WATERLOO METRO QUARTER BUILDING 3&4

SSD-10437 - RESPONSE TO SUBMISSIONS
SUPPLEMENTARY DESIGN REPORT

PREPARED FOR WATERLOO DEVELOPER PTY LTD
DOCUMENT NO. WMQ-BLD34-BSA-AR-RPT-DA210

Revision A

NORTH ELEVATION SHADING DIAGRAM

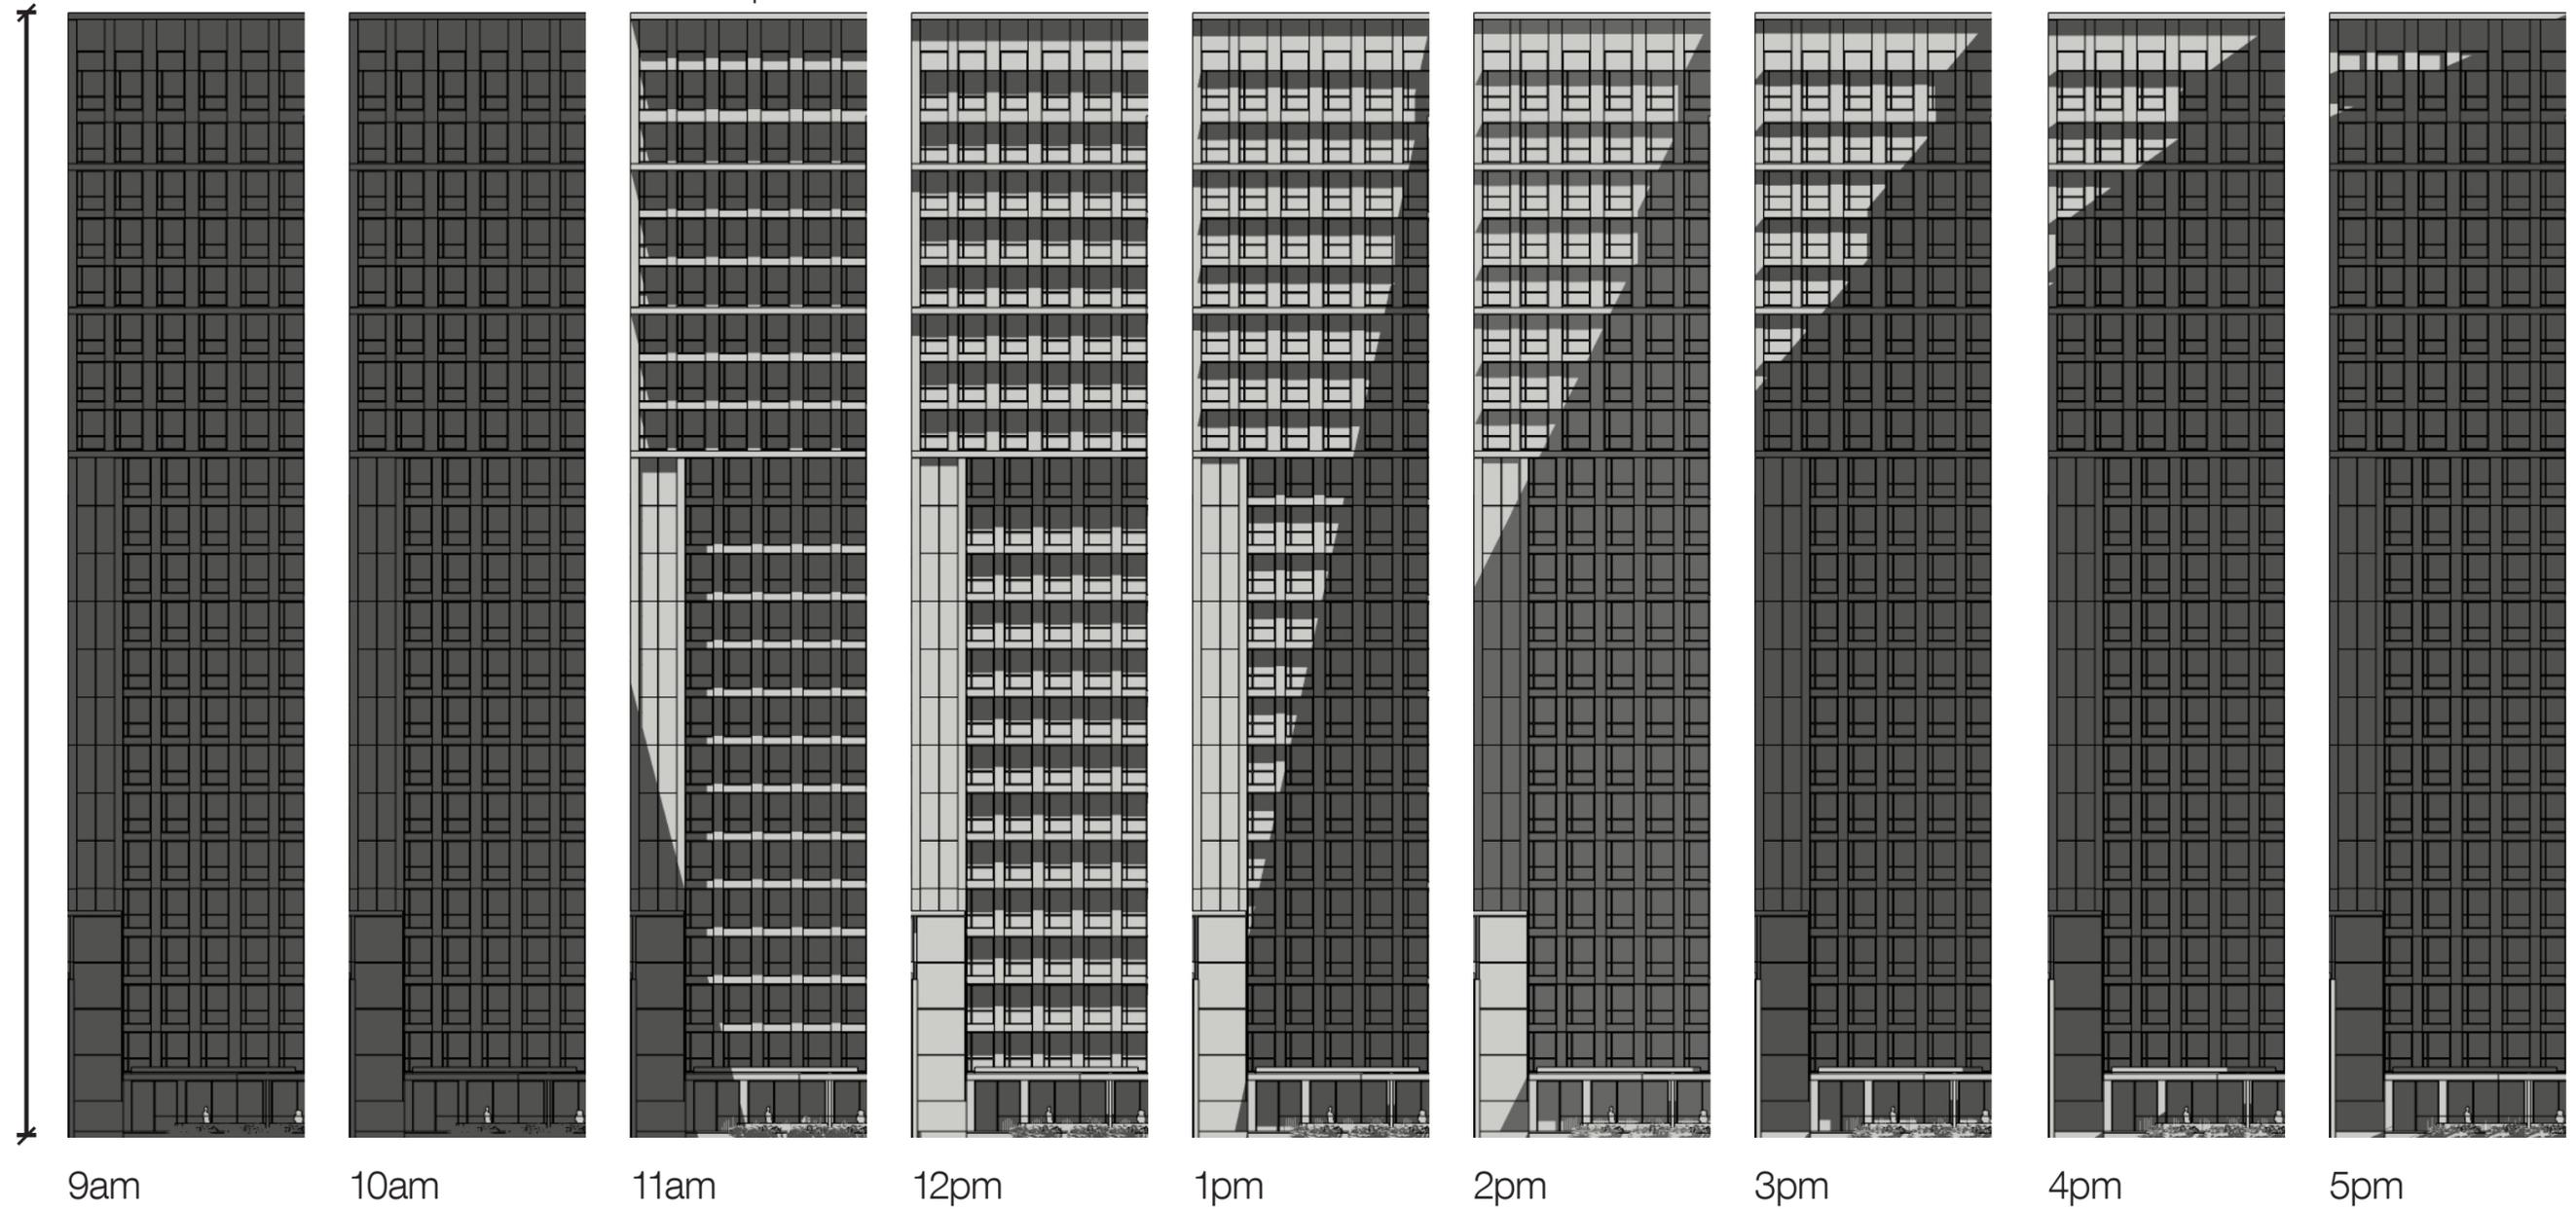
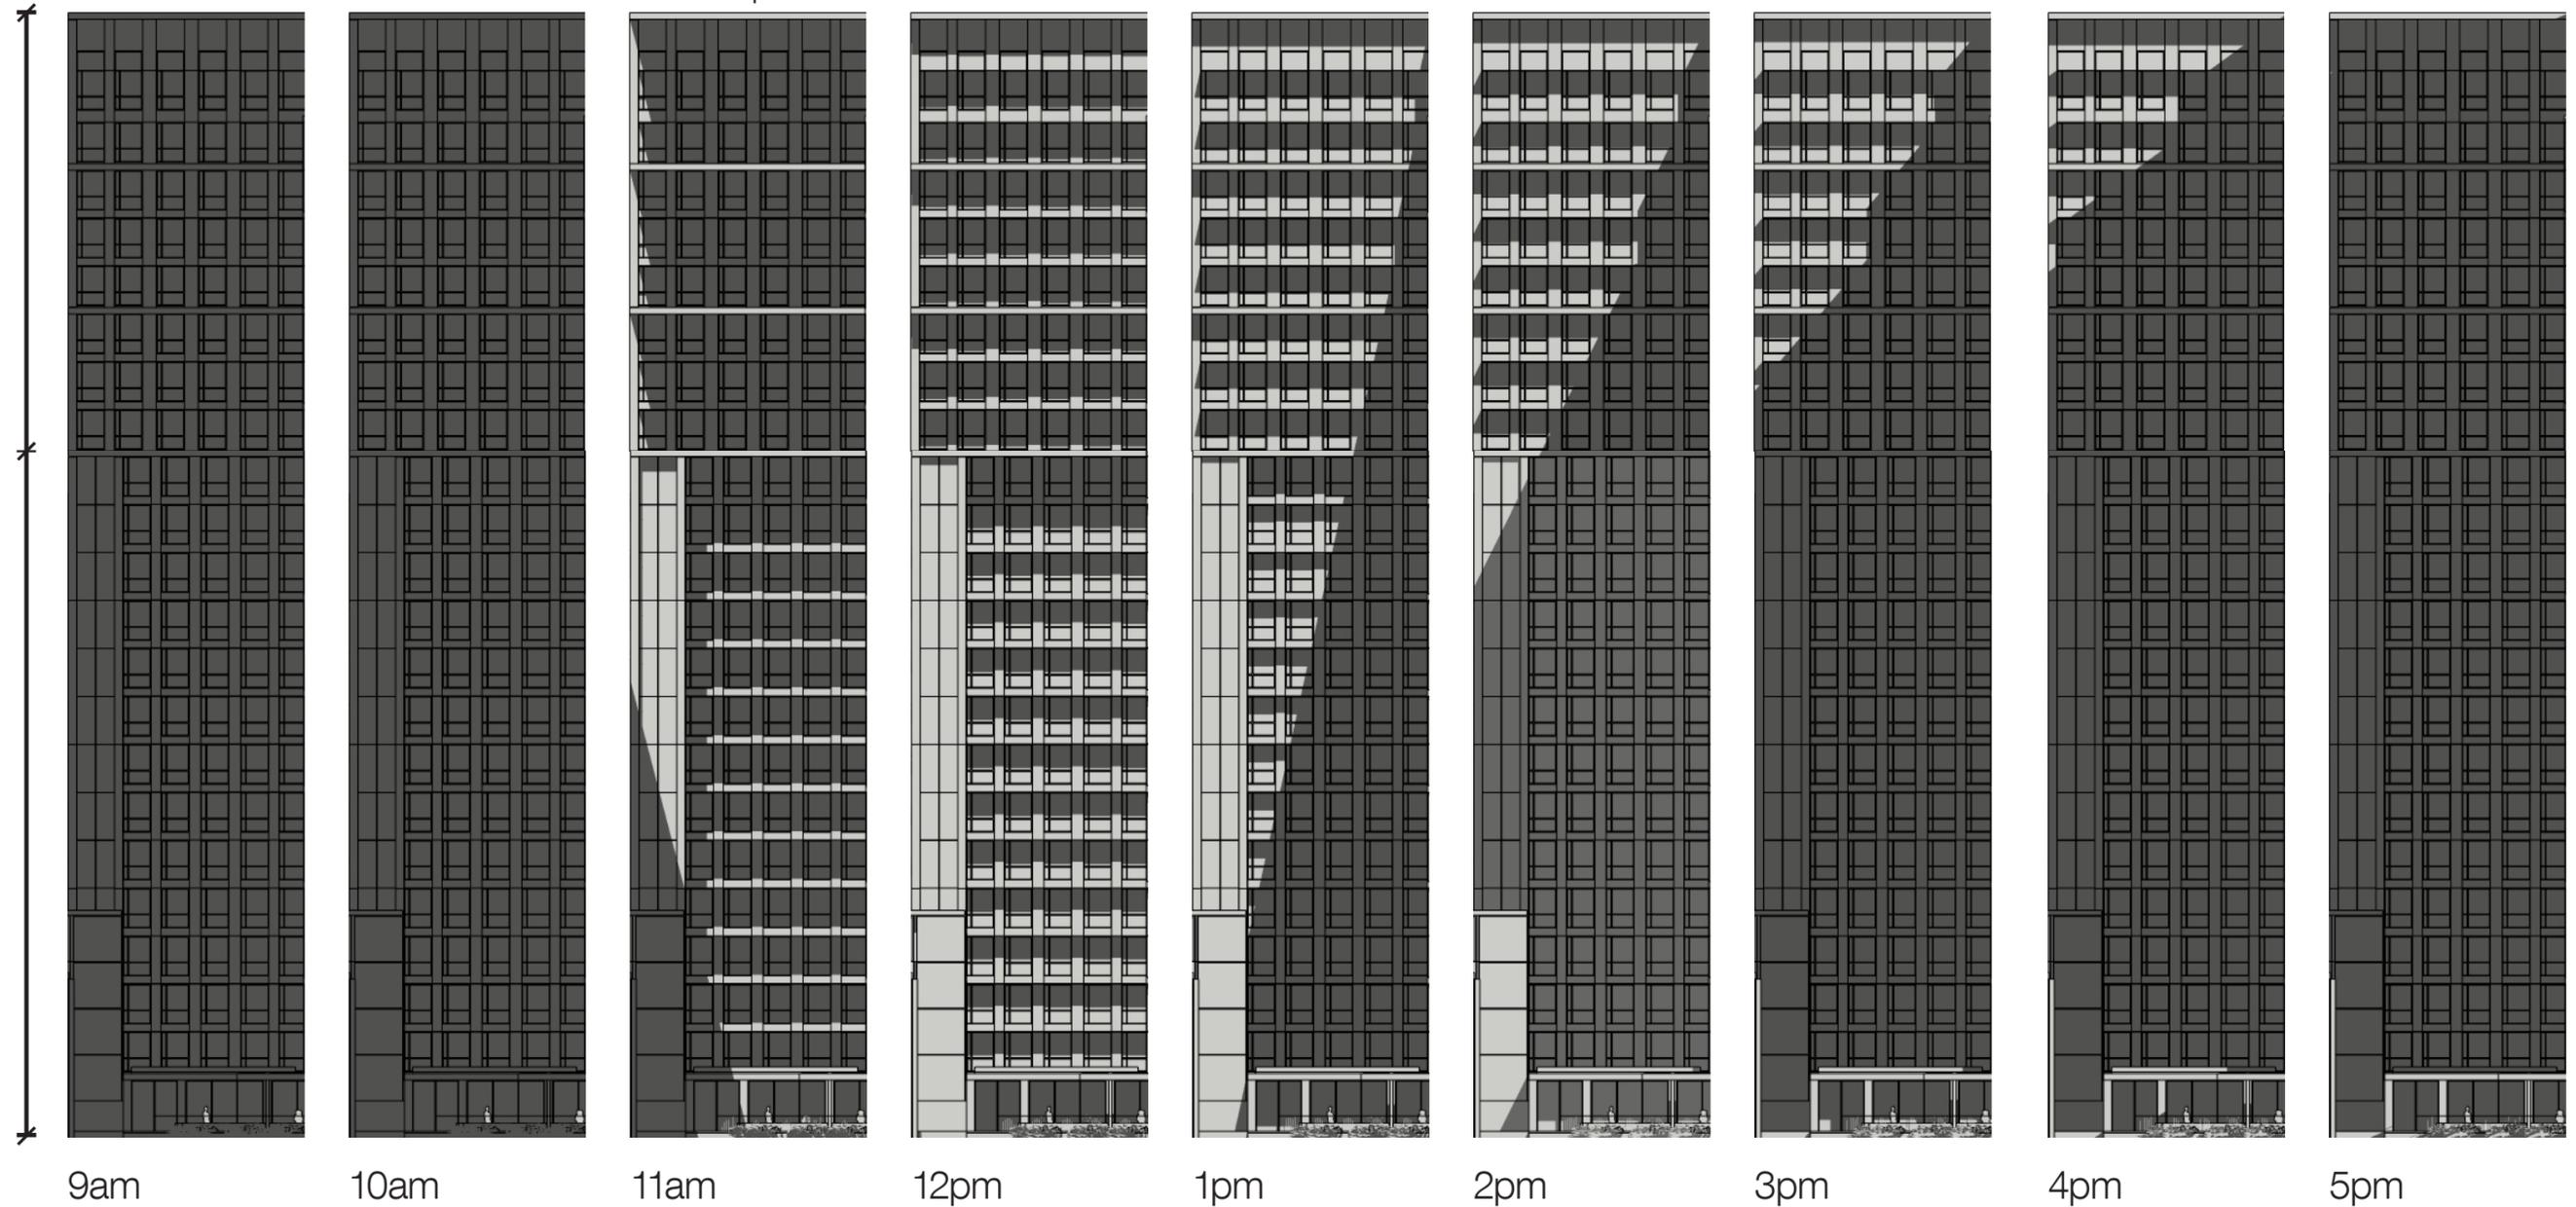
On the northern facade, the design does not provide any shading. The design concept would not be compromised through the addition of horizontal shading elements, which could be incorporated within the window framing, similar to the proposed “thin horizontal sunshade” which is proposed on the western elevation. On the western elevation, the horizontal sunshade has no effect on low altitude afternoon summer sun. The Design Integrity report notes that prior to closing out this issue, the Panel was supportive of the proposed ‘moveable screens’ solution. This has now been removed from the scheme and further endorsement should be sought from the Panel. The application of both changes discussed above could easily be achieved through a condition of consent and the City is able to provide the wording upon request.

The north facade currently has 250mm horizontal sunshades located directly above each window.

The north elevation is heavily shaded by the adjacent buildings, particularly to the lower levels, which help reduce the overall heat load on the northern elevation. As the upper levels are less shaded by adjacent buildings, the horizontal sunshades to Level 16-23 are proposed to be increased to 400mm deep, to match the depth of the horizontal sunshades on the western elevation, per the City of Sydney recommendation. Refer to the following pages for further detail.

Horizontal sunshades increased in depth to 400mm to Levels 16-23. The deeper sunshades allow the north facing windows to be entirely in shade throughout the day at mid summer.

Studios to these levels are shaded to a lesser extent by the adjacent buildings.

250mm deep horizontal sunshades retained to Levels 03-15.

Studios to these levels are heavily shaded throughout the day by adjacent buildings.

Communal Terrace Wind Comfort Results
Analysis by RWDI

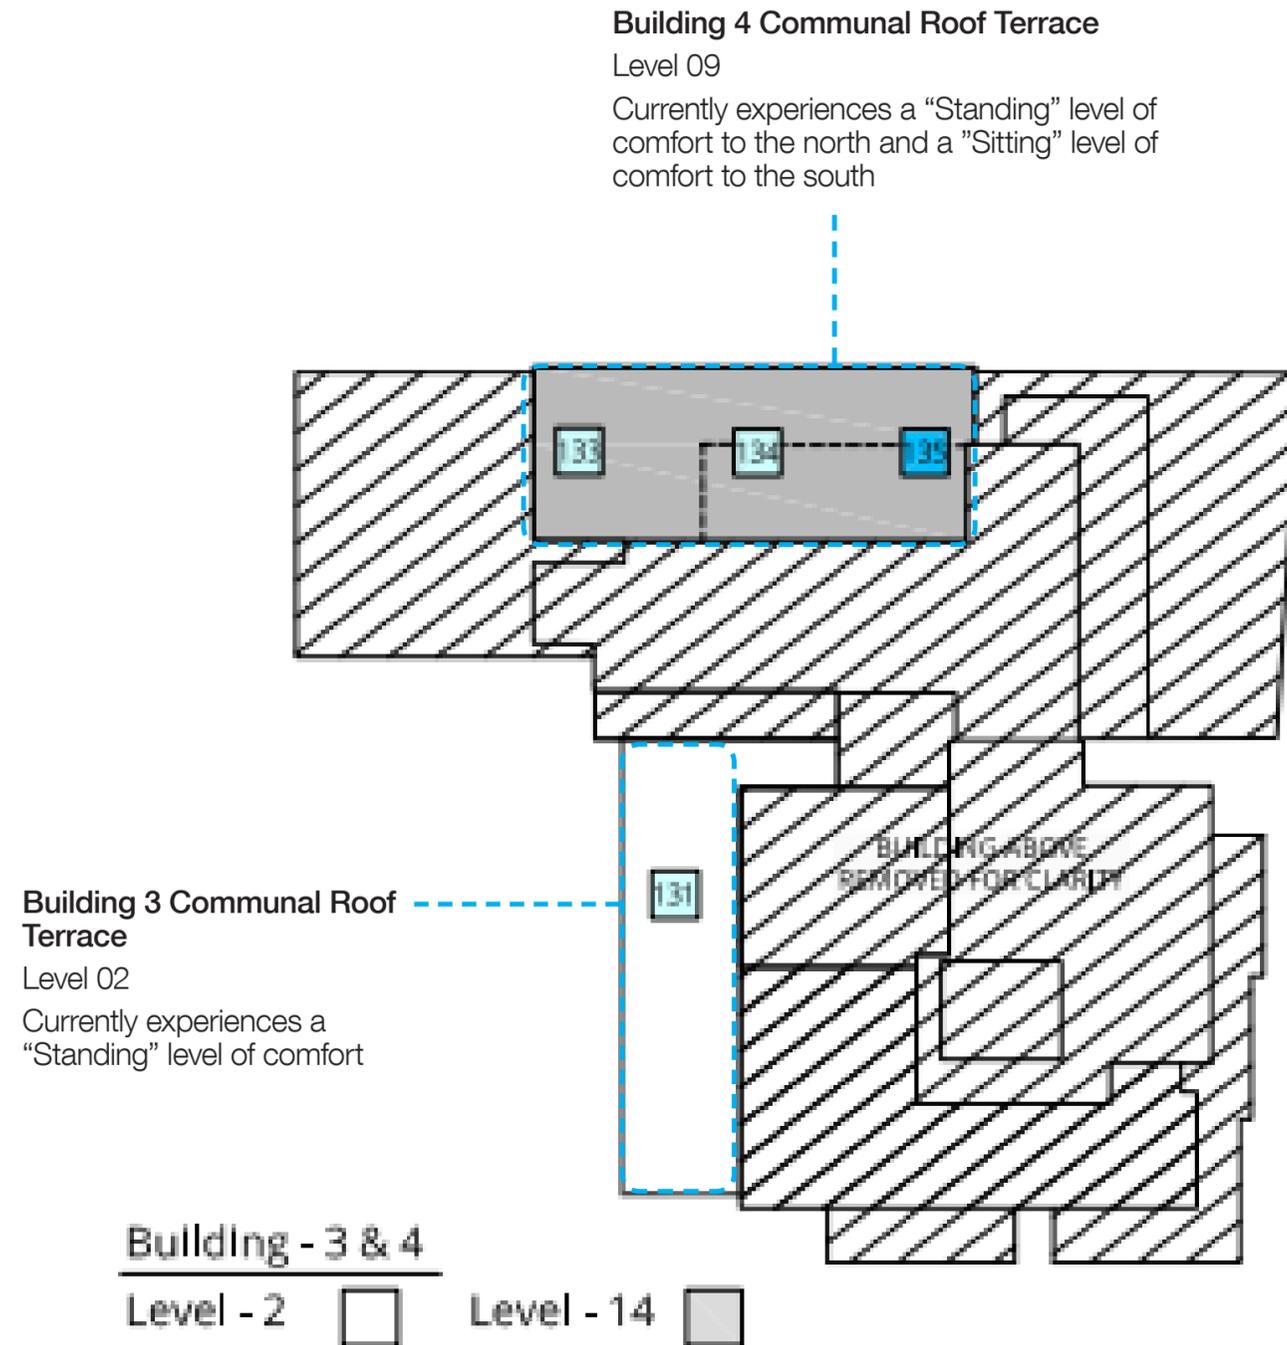
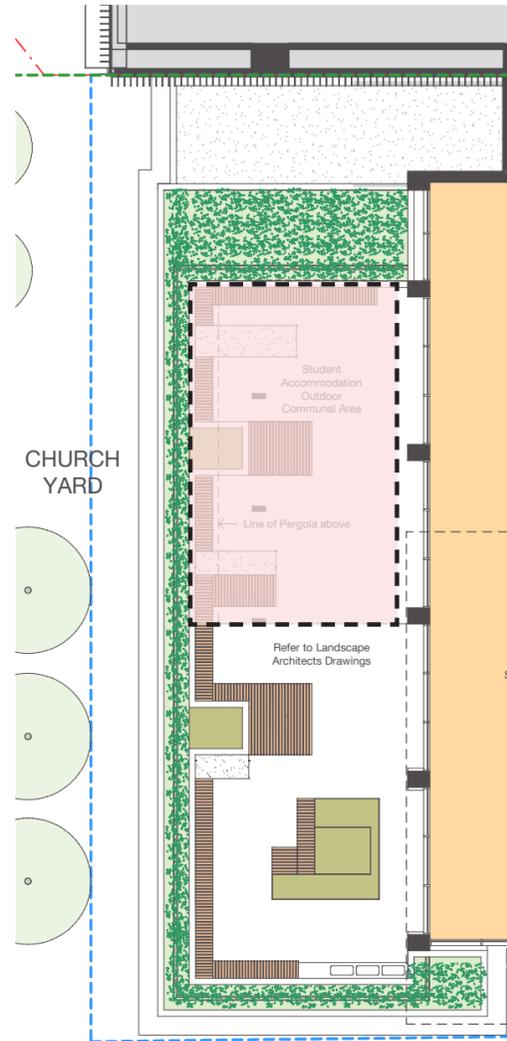
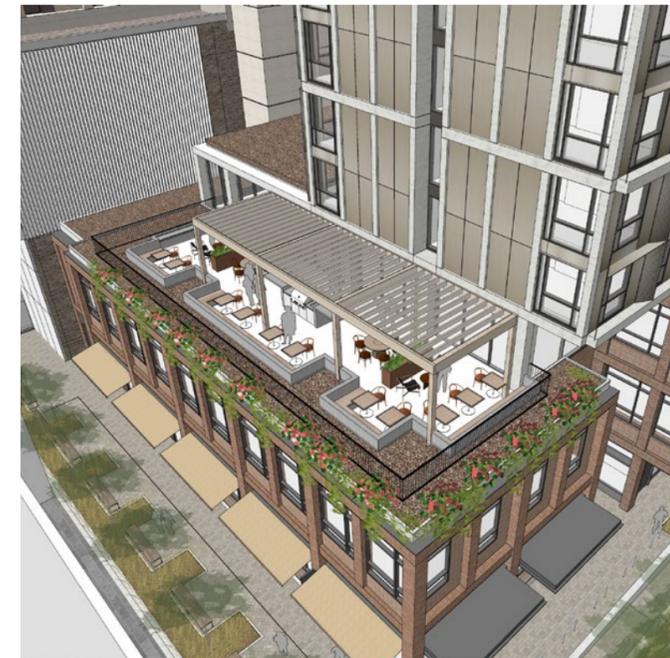
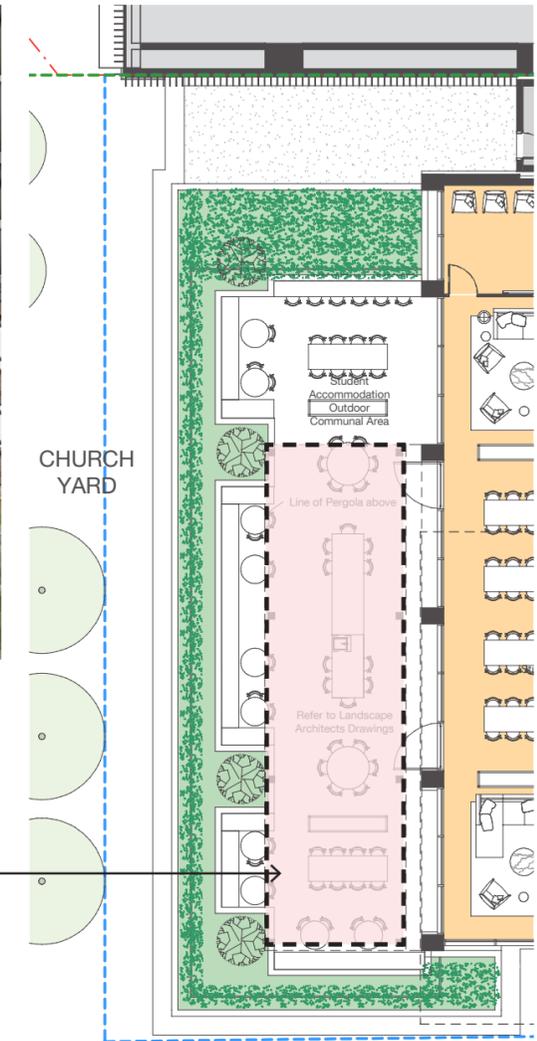
The wind report identifies that the communal terrace will only achieve the standing comfort criteria, even accounting for mitigation measures. It is preferable that further design work be undertaken to try to improve the amenity of this area for residents such that it meets the sitting comfort criteria.

The wind conditions affecting the Building 3 roof terrace are primarily generated from downwash from the tower above.

The pergola to the communal roof terrace has been developed in response to the City of Sydney comments by amending the following:

- / Pergola moved further west to align with the tower above
- / Pergola length increased
- / The pergola is proposed to have operable openings to allow for solar access in winter whilst still providing weather protection

Pergola moved further west (towards Botany Road) and length increased to help reduce wind downwashing off the tower form above to improve wind conditions on the communal terrace
